DSP-20005

Washington Pentecostal Assembly

STAFF REPORT

SUBJECT: Detailed Site Plan DSP-20005
Washington Pentecostal Assembly

WEST VIEW ELEVATION

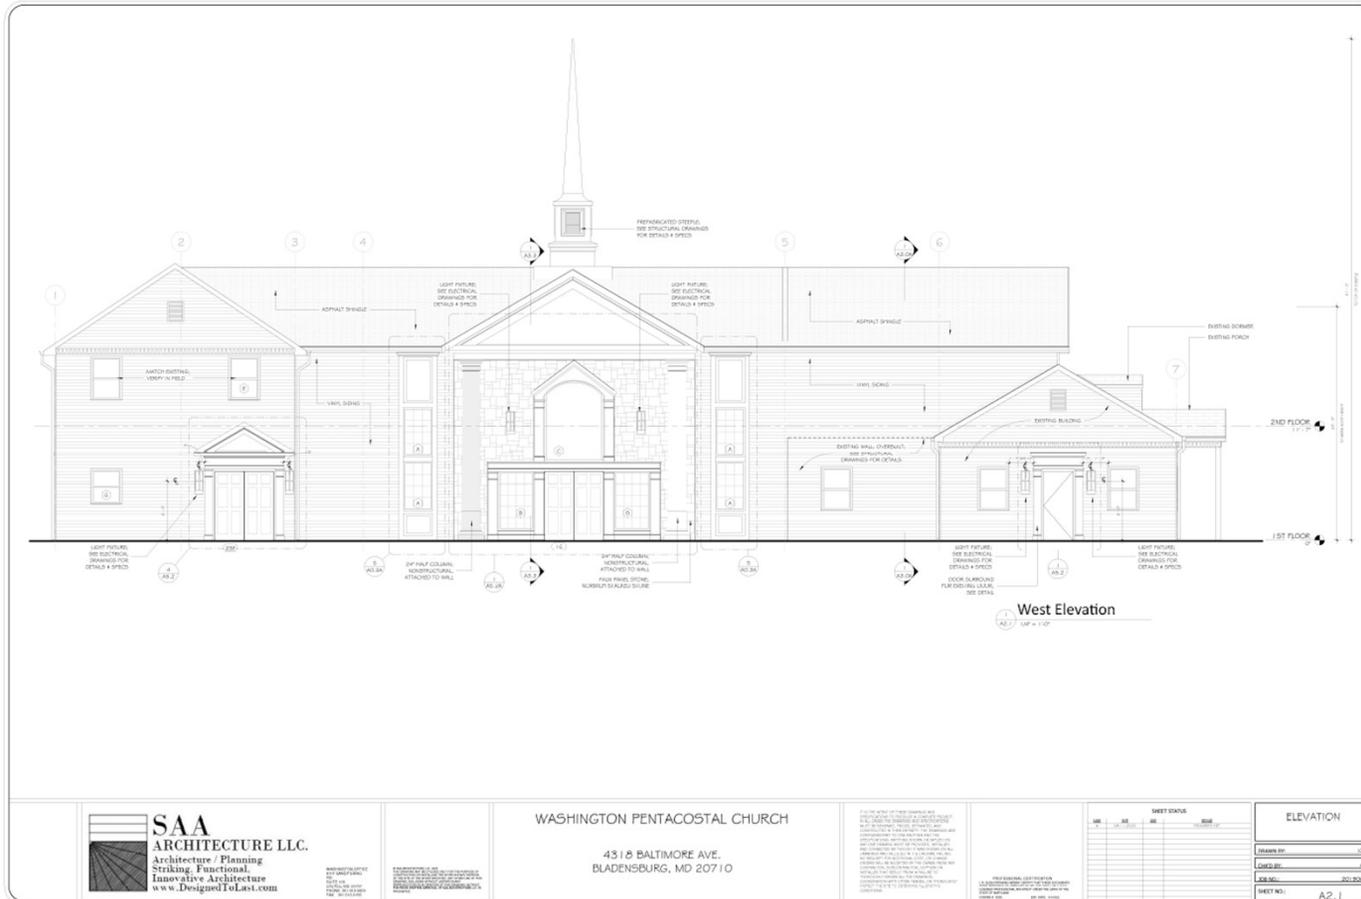
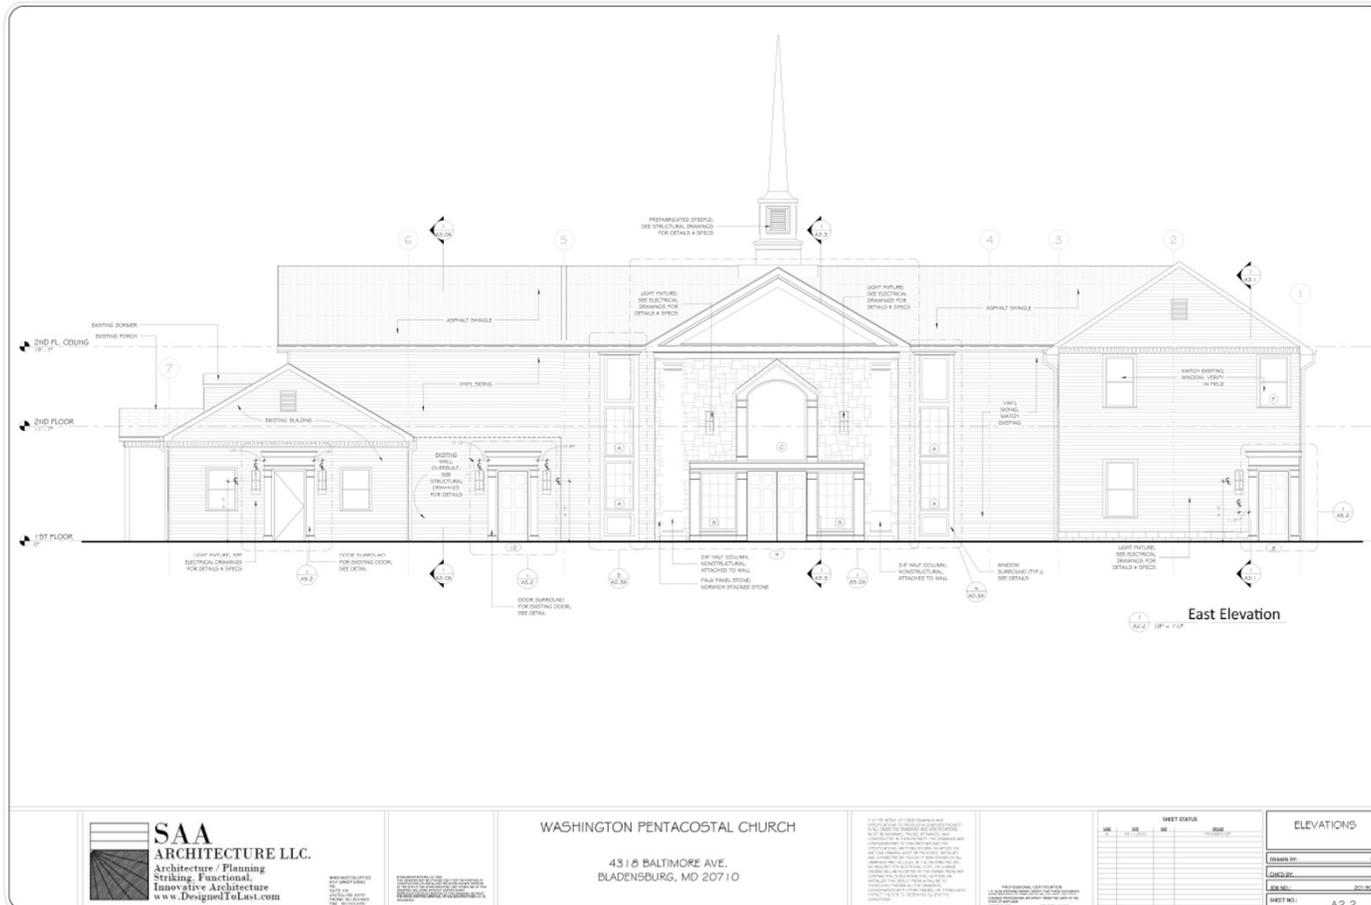
- b. **General Building Envelope Standards for Elements – Fenestration (page 176):** Per the General Building Envelope Standards for Elements section of the sector plan, ground-level façade fenestration shall comprise between 40 and 90 percent of the façade and the upper-story shall be between 20 and 60 percent. Given the fact that the proposal is improving the existing building fenestration within the range not to impede the structural integrity, staff can generally support the modification. However, the applicant should provide further improved fenestration, to the extent possible, with exhibits showing the percentage of the opening, and reviewed by urban design staff for certification. Therefore, the condition is included herein.

- d. **Storefront Building Envelope Standards for Elements – Fenestration (page 180):** Similar to the modification requested for the General Building Envelope Standards for Elements – Fenestration, the applicant is requesting to modify the façade fenestration requirement. Per the Storefront Building Envelope Standards for Elements section of the sector plan, ground-level façade fenestration must be between 40 and 90 percent of the façade. The existing building does not meet this requirement, and even with the proposed stone vestibule with glass and large doors, the building will not meet the fenestration requirement. Similar rationales apply from the General Building Envelope Standards for Elements to this modification.

- (1) Detail sheet for items such as the prefabricated steeple and building materials.
 - (2) Improve fenestration (larger or additional windows and doors allowing light and views) for building elevations and obtain approval from Urban Design staff. Diagrams showing the percentage of openings should be provided as well.

EAST SIGN DETAIL (Existing)
1/4" = 1'-0"

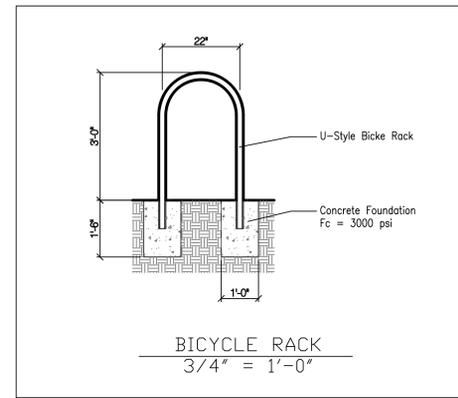
- e. **Architectural Standards – Signage – General Design and Materials (page 196):** Per the Architectural Standards for Signage – General Design and Materials section of the sector plan, sign types such as freestanding and monument are prohibited. There is an existing freestanding sign and an existing monument sign on the subject site. The application is not proposing to add new signage to the site, but rather to reface the existing signs.

The applicant is requesting a modification to the development standards, to allow for the refacing of the signs. The applicant stated that the signs are necessary to maintain because they will assist drivers in locating the place of worship, which is partially obscured from the north and south by vegetation. The development standards are intended to regulate signage for new construction with buildings closer to the street. As the existing building is set back 30 feet, even if the signage is provided as design standards, the legibility and visibility would be minimal by drivers.

This request will not substantially impair implementation of the sector plan and staff recommend approval of this modification.
